From:	Sweeney,Katie [KSweeney@nma.org]
Sent:	Wednesday, October 08, 2008 2:40 PM
То:	NRCREP Resource
Subject:	Uranium Recovery GEIS
Attachments:	DGEIS Cover letter.pdf; NMAcommentsisrgeisfinal (2).pdf

SUBJECT: National Mining Association Comments Regarding the Nuclear Regulatory Commission's Draft Generic Environmental Impact Statement on In Situ Uranium Recovery Facilities (NUREG-1910)

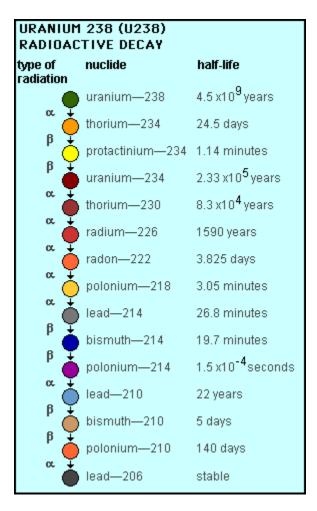
77. <u>Page 3.1-4, Figure 3.1-3</u>: NRC should note that its discussion of the southern boundary of the Nebraska Region does not currently include potential expansion areas for Crow Butte Resources such as Marsland, Nebraska. NMA believes that this area should be included to reflect a more complete picture of this region.
